17TH STREET CANAL - PHASE 1B

HAMMOND HIGHWAY TO SOUTHERN RAILWAY

The following revised slope stability and sheet pile design calculations address all comments made in the Corps' letter of April 25, 1989. A brief description of the revisions made to the cross-sections since the last submittal of April 10, 1989, is given for each of the eight reaches. Also given for each of the reaches is a listing of new submittals, stating which of the Corps' comments were addressed.

STA. C04+00

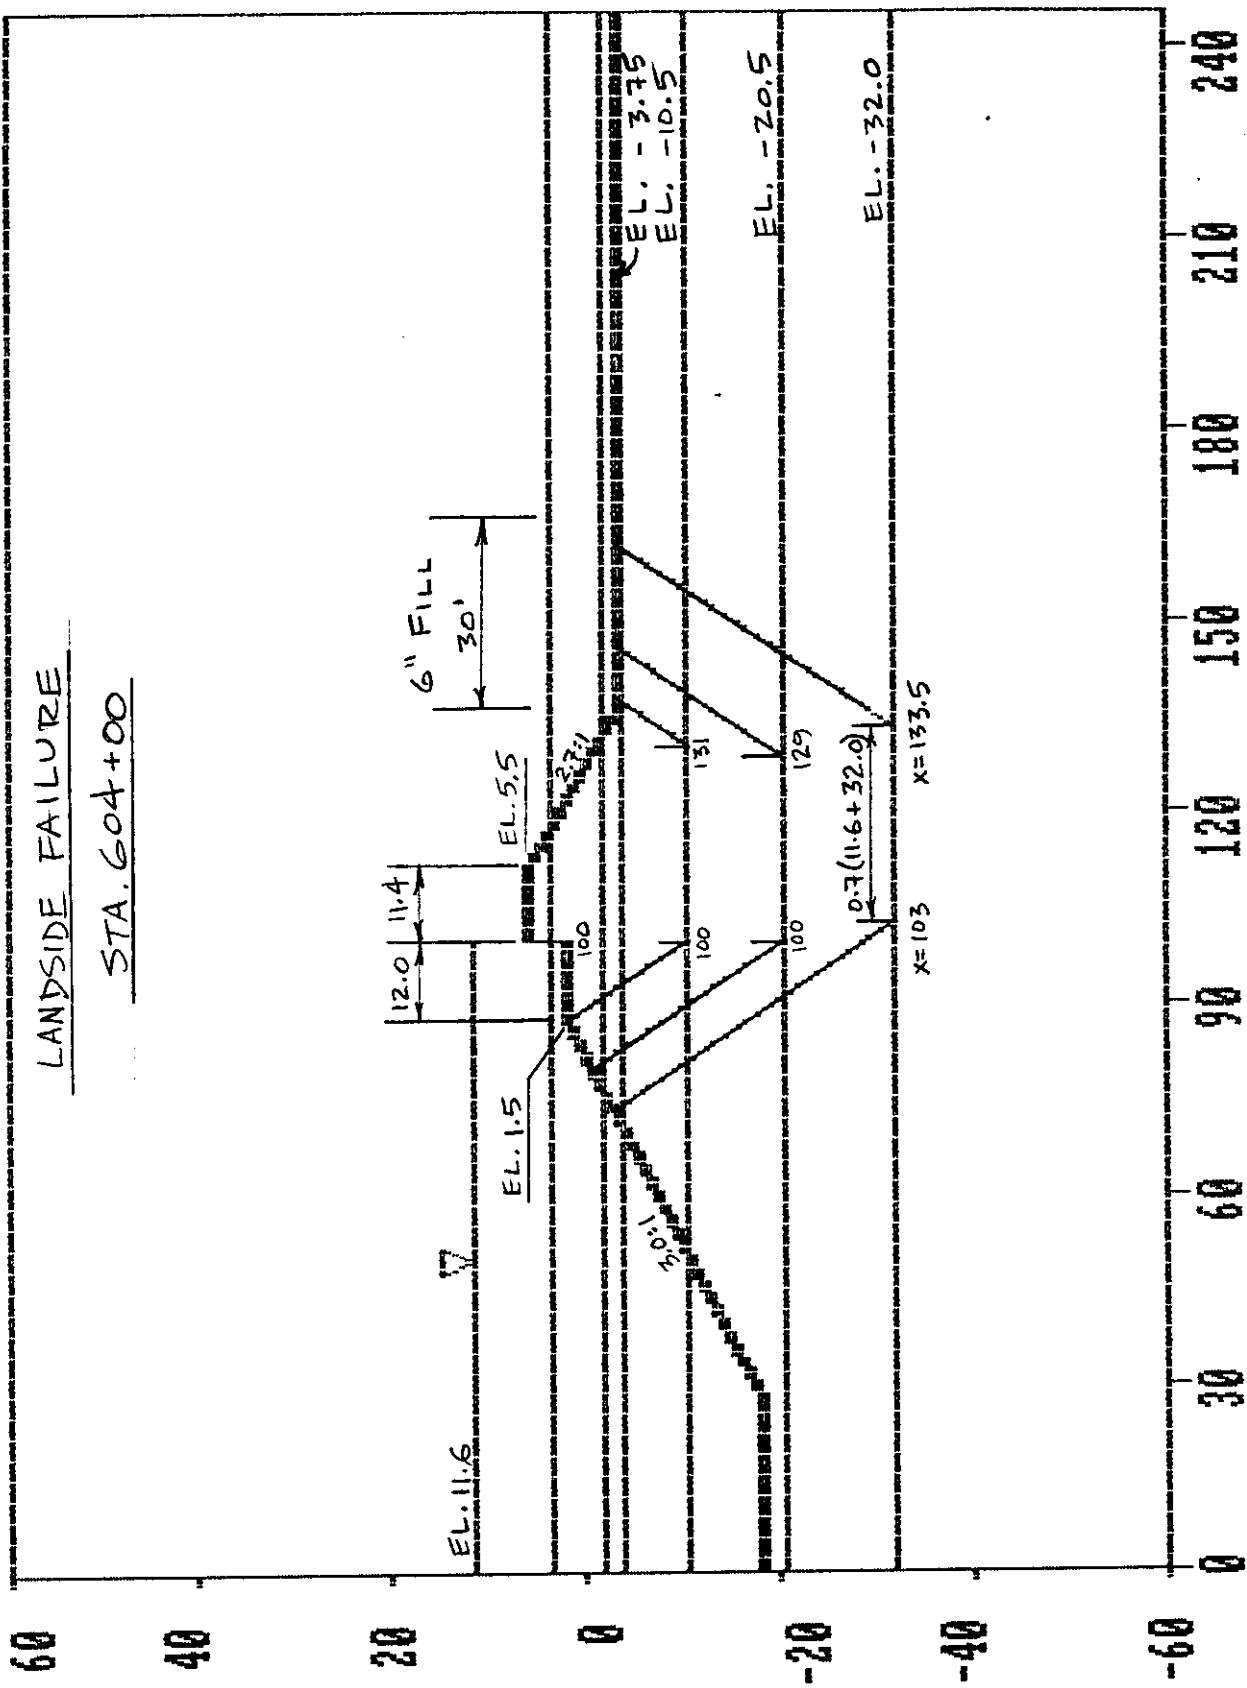
1. New canalside stability analyses taking into account the above revisions and the correction to the soil shear strength from El. 0.0 to El. -2.0.
2. New landside stability analyses taking into account the above revisions and including calculations at El. -10.5 and El. -20.5.
2. New sheet pile analyses taking into account the above revisions and the submerged canalside soil weight.

Reach 3 landside stability analysis at El. -32.0 with the active wedge at $x=110$ and the passive wedge at $x=140.5$ does yield a lower factor of safety than with the wedges at $x=111$ and 144.5 respectively, as previously submitted. However, it has since been discovered, that placing the active wedge at $x=103$ and the passive wedge at $x=133.5$ yields the lowest factor of safety. Therefore these calculations are being submitted in lieu of the requested location.

Landside Failure - 598+00, 592+00, 594+00, 596+00, 600+00, 604+00 and 606+00. The section
at Sta. 604+00 governs. *** Minimum Factor of Safety = 1.30 at El. -20.5 ***

CANAL SIDE FAILURE
STA. 614+00

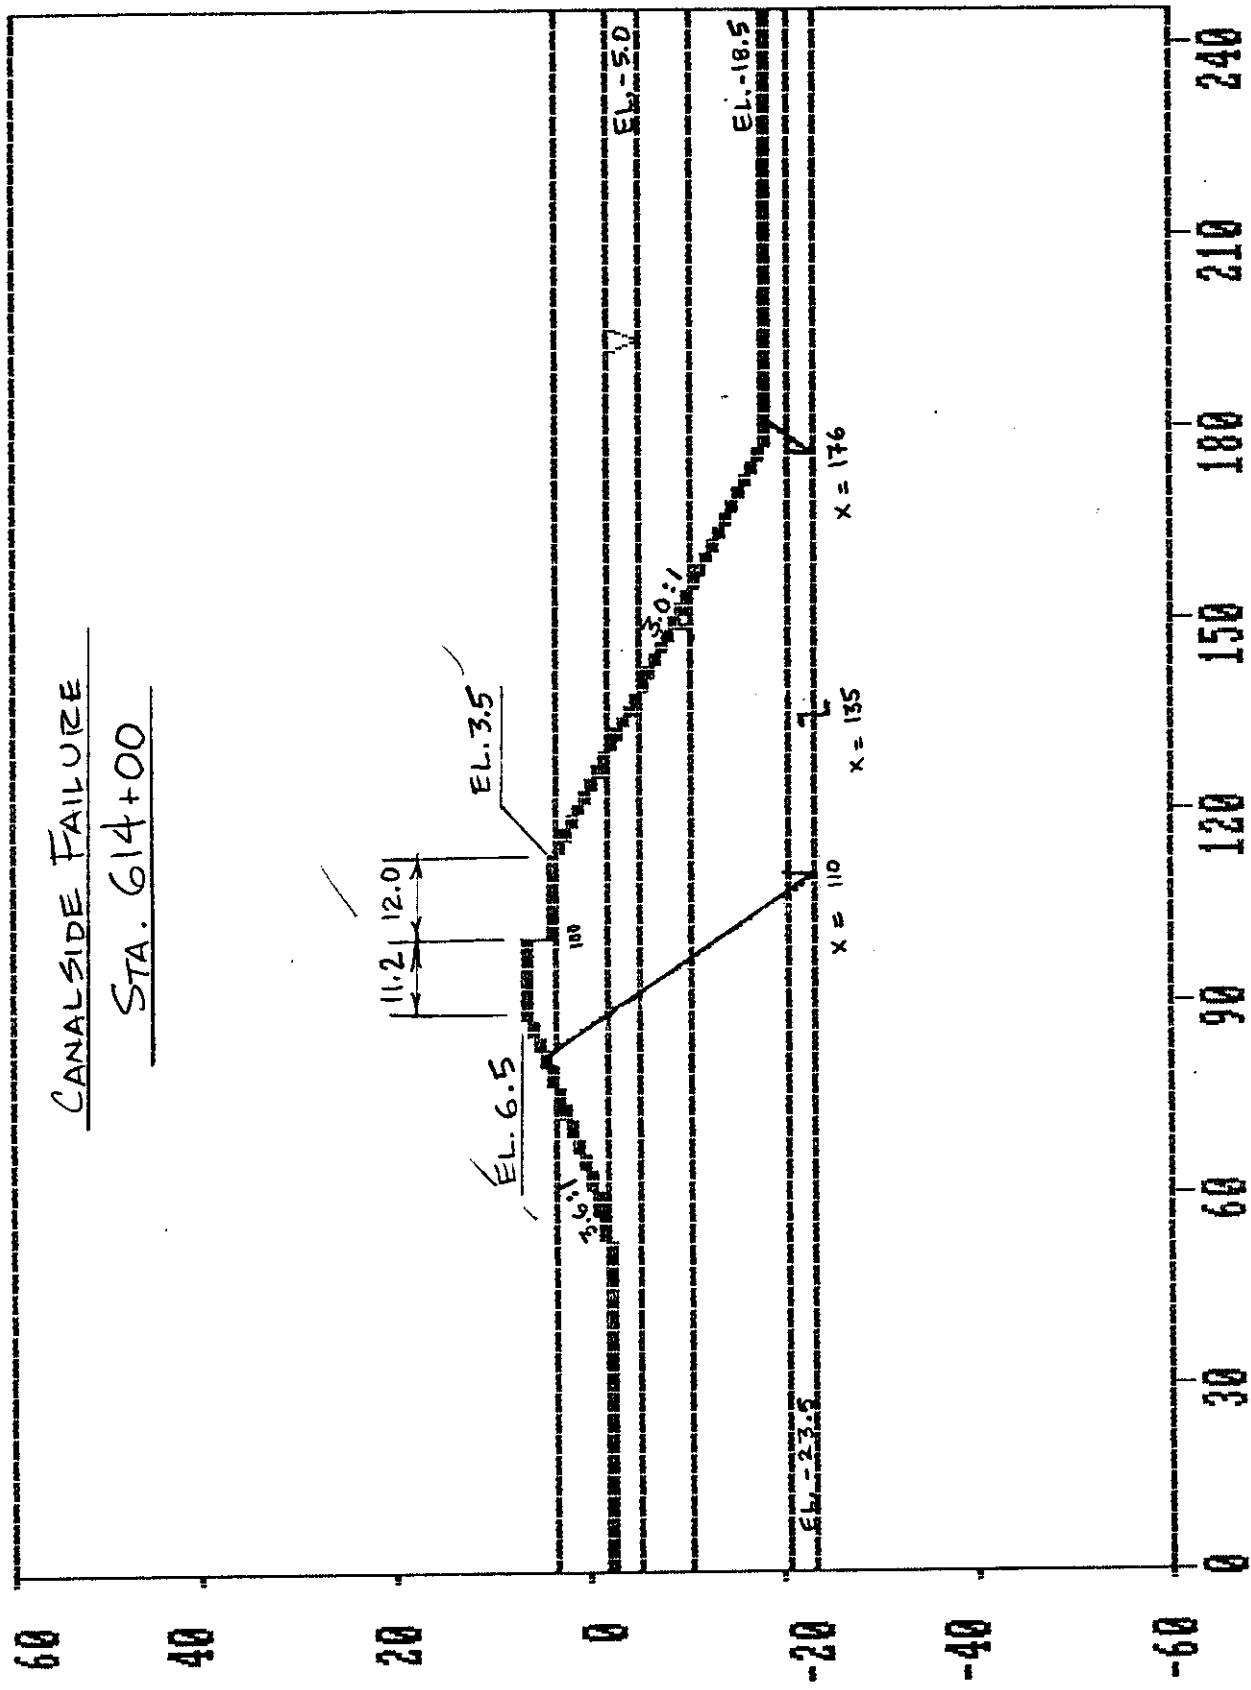
1. Entire sheet pile wall moved 0.5' closer to the canal thus increasing the crown width 0.5' along the entire reach.
2. Crown elevation lowered from El. 7.0 to El. 6.5 thus increasing the crown width an additional amount which depends on the backslope at each station.
3. Step elevation lowered from 3.6 to 3.5.
4. Step width increased from 9.0' to 12.0'.

1. New canalside stability analyses taking into account the above revisions, the correction to the soil shear strength from El. 0.0 to El. -2.0, and the piezometric headline of El. -2.4 in the sand.
2. New landside stability analyses taking into account the above revisions.
3. New sheet pile analyses taking into account the above revisions and the submerged canalside soil weight.

Canalside Failure - 614+00 and 616+00. The section at Sta. 614+00 governs.
*** Minimum Factor of Safety = 1.38 at El. -23.5 ***

CANAL-SIDE FAILURE
STA. 627 +28 /

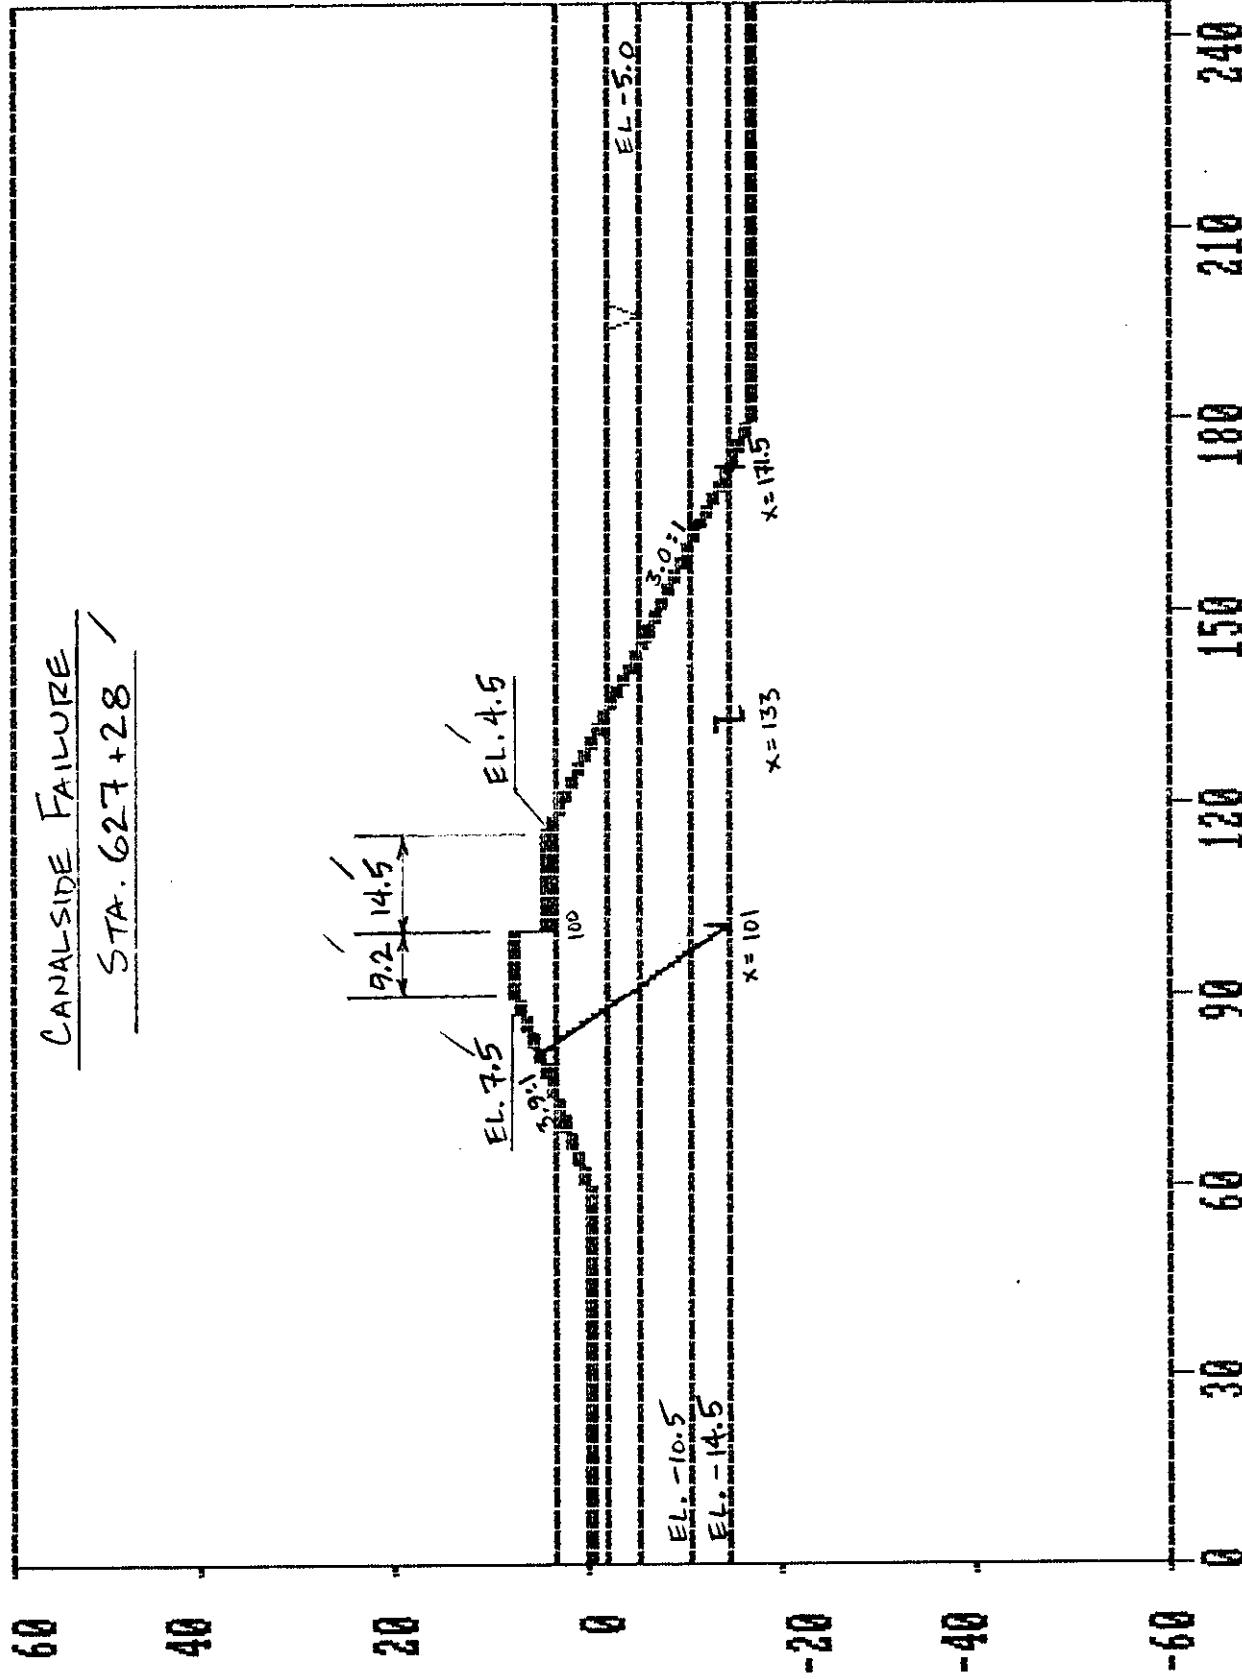
1. Step elevation lowered from 5.5 to 4.5.
2. Step width increased from 8.5' to 14.5'.

1. New canalside stability analyses taking into account the above revisions, the correction to the soil shear strength from El. 0.0 to El. -2.0, and the piezometric headline of El. -2.4 in the sand.
2. New sheet pile analyses taking into account the above revisions and the submerged canalside soil weight.

Canalside Failure - 627+28.
*** Minimum Factor of Safety = 1.30 at El. -14.5 ***

STA 665+00

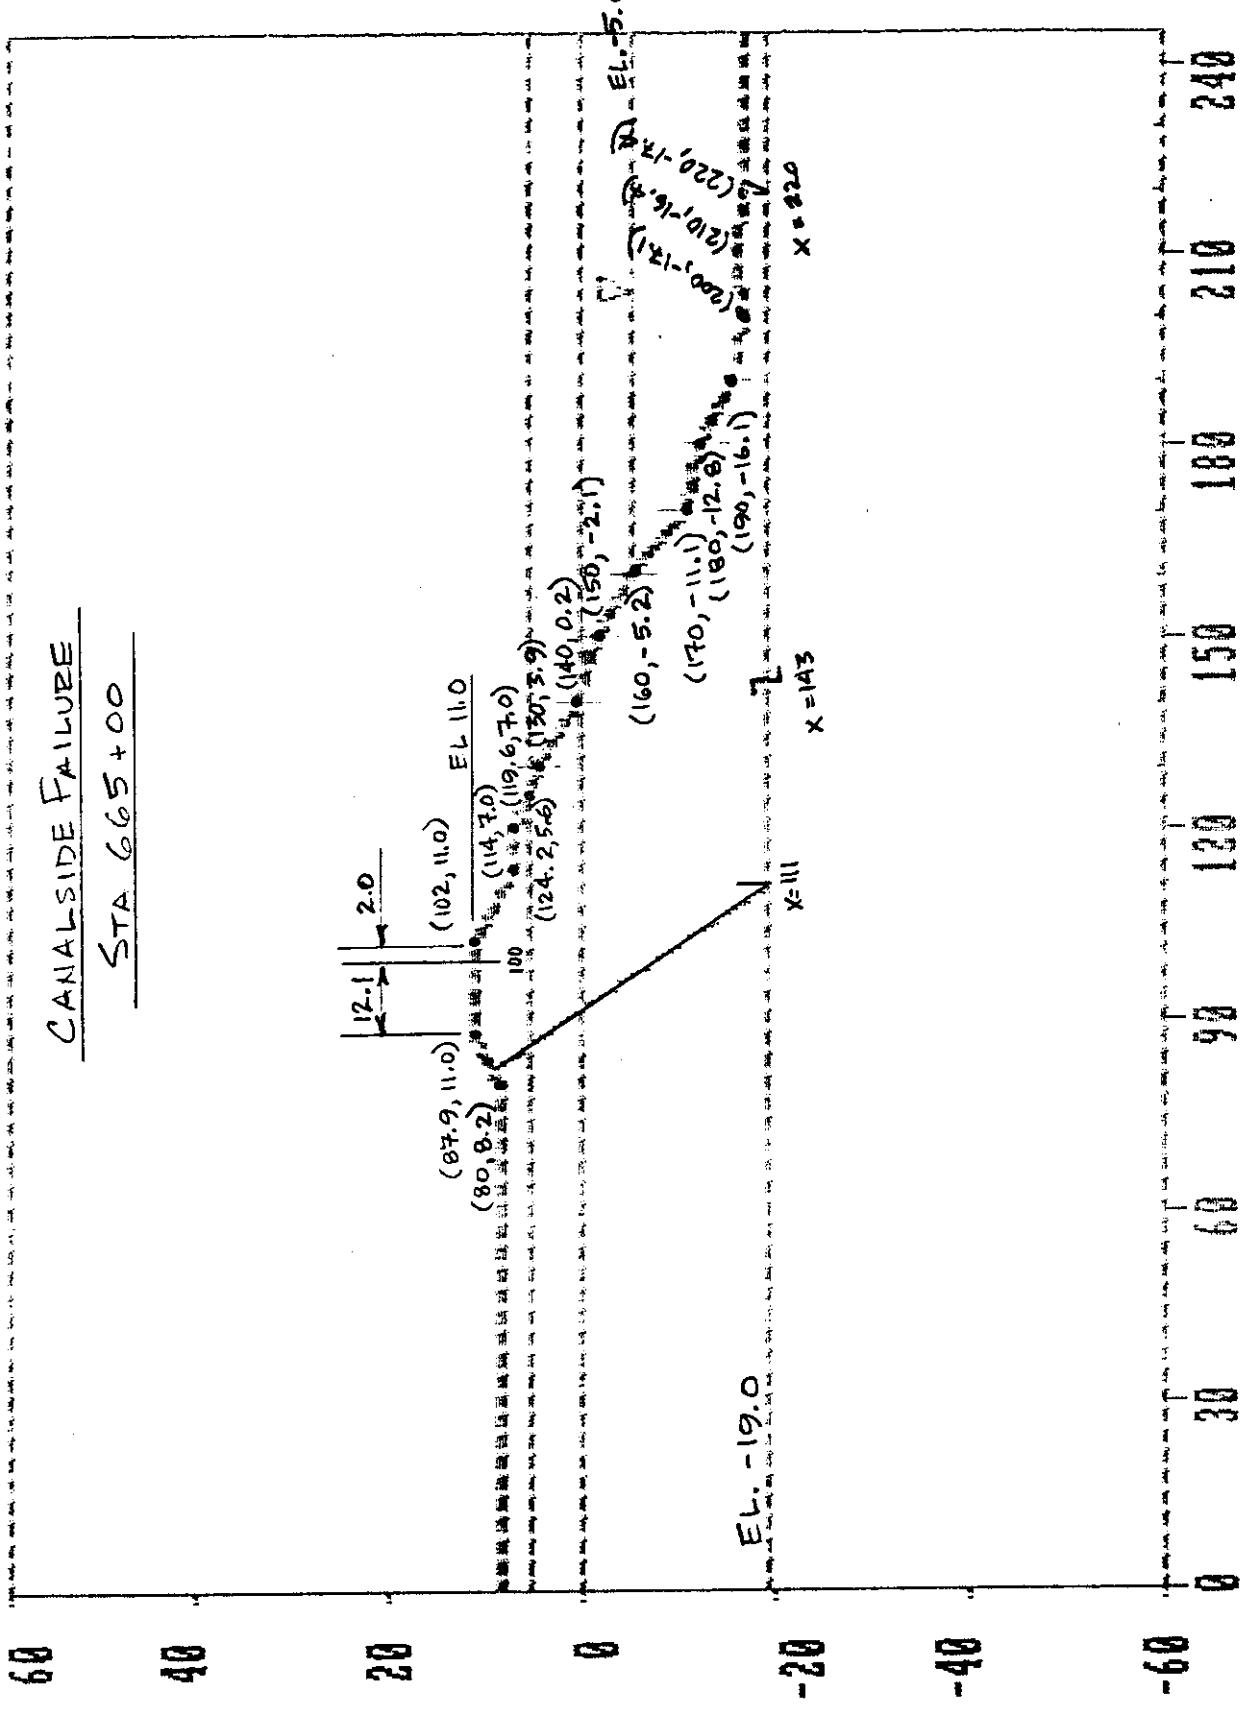
1. Sheet pile alignment changed.
2. Crown elevation lowered from El. 12.0 to El. 11.0.
3. Crown width behind the sheet pile wall changed from a constant 8.0' to a varying width between the sheet pile wall and El. 11.0 on the existing backslope.
4. Step elevation raised from El. 2.0 to El. 7.0.
5. Step width changed based on the above revisions.

1. New canalside stability analyses taking into account the above revisions and the piezometric headline of El. -2.4 in the sand.

Canalside Failure - All cross-sections were checked. The section at Sta. 665+00 governs.
 *** Minimum Factor of Safety = 1.32 at El. -19.8 ***
